**PLANNED UNIT DEVELOPMENT &
SUBDIVISION STAFF REPORT**

Date: April 17, 2003

DEVELOPMENT NAME 147 Westfield Avenue

SUBDIVISION NAME 147 Westfield Avenue Subdivision

SITE PLAN

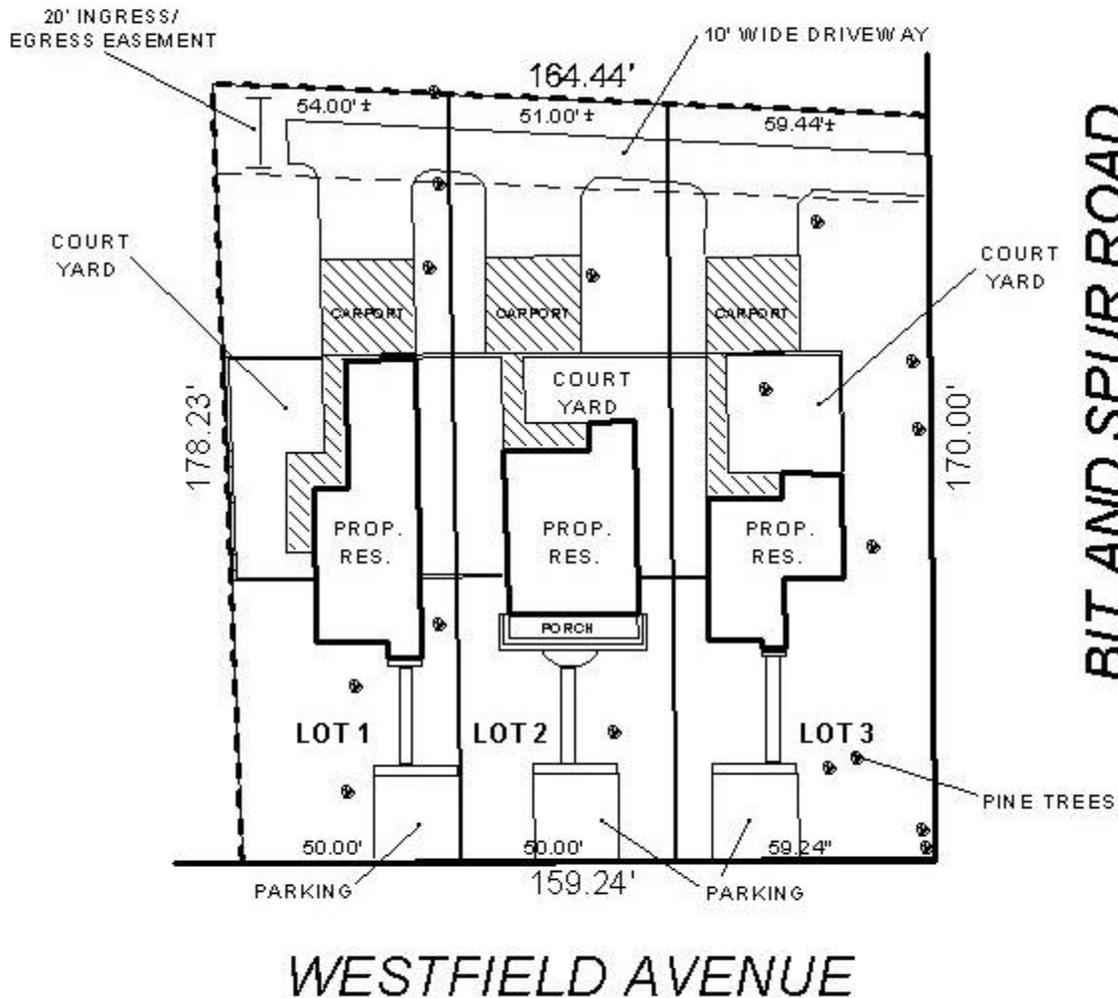
Must comply with all stormwater and flood control ordinances. Any work performed in the right of way will require a right of way permit. No common area for stormwater detention shown on plat. Stormwater detention is required and should be constructed prior to approval of final plat. Creation of homeowners association also required to maintain storm water system. The specific radius of the intersection of Bit & Spur and Westfield was not shown on preliminary plat. If the radius is not 25 feet, the Engineering Department recommends dedication to meet a 25 foot radius.

Driveway number, sizes, location and design to be approved by Traffic Engineering and conform to AASHTO standards. Driveway number, size, location, and design to be approved by Traffic Engineering and conform to AASHTO standards. To allow for two-way traffic the private drive should be a minimum of eighteen feet wide.

Comments from the City Engineering Department indicate that no common area for detention is shown on the plat and further state that detention for the subdivision is required. There is some concern that this requirement could have a major impact on the site design. Other Engineering Department and Traffic Engineering Department comments that would have an impact on the development relate to the dedication of a 25' radius at the intersection of Bit & Spur Road and Westfield Road, and a requirement that the access drive be a minimum of 18' wide to allow for two-way traffic.

The applicant's engineer has been made aware of these comments and has indicated that the drive could be increased to 16', and that the 25' radius could be dedicated if it did not reduce the lot to less than 7,200 sq.ft. The applicant's engineer did, however, indicate that contact would be made with the Engineering Department regarding the detention issue.

RECOMMENDATION **Planned Unit Development:** based on the preceding, it is recommended that this application be approved subject to the following conditions: 1) limited to the site plan submitted, as required to be amended by this approval; 2) provision of detention facilities, as required by the Engineering Department; 3) dedication of 25' radius at the intersection of Bit & Spur Road and Westfield Road; 4) the shared access drive be paved to a width of 16'; and 5) full compliance with all municipal codes and ordinances.

Subdivision: based on the preceding, it is recommended that Section V.D.2 (minimum width) be waived and the plat granted Tentative Approval subject to the following conditions: 1) limited to the accompanying PUD; and 2) dedication of a 25' radius at the intersection of Bit & Spur Road and Westfield Road.
